Proposals from IWG-R55 to GRRF-82

- Minor corrections and clarifications
 - Typos in Annex 5 figures 12 and 17

Amend figure 12 to read:

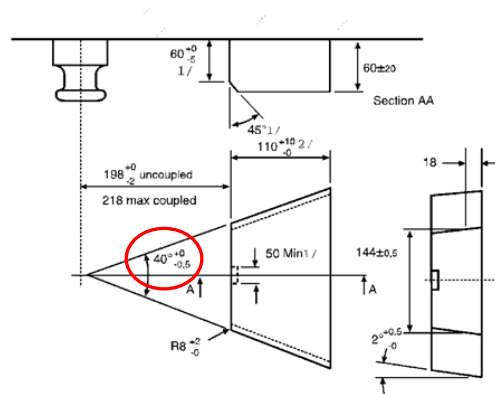
Change dimension sleeve bore diameter ~~Ø6H8~~ to **Ø60H8**

Trade-Off

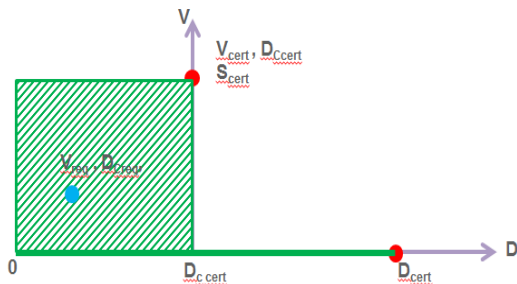
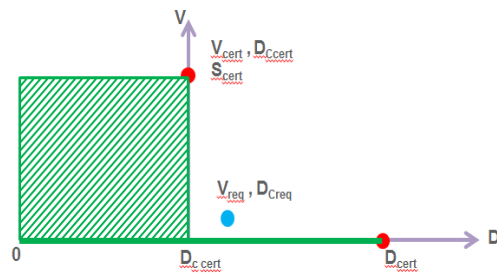
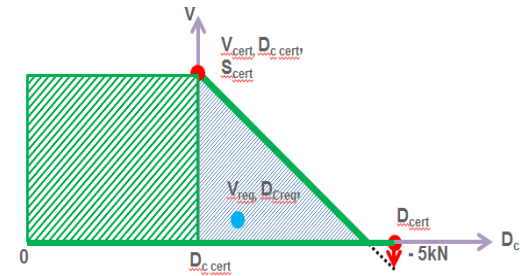
- Adding D_c/V -trade-off possibility to annex 8
 - Some multi vehicle combinations require high D_c -performance in combination with a low V -performance
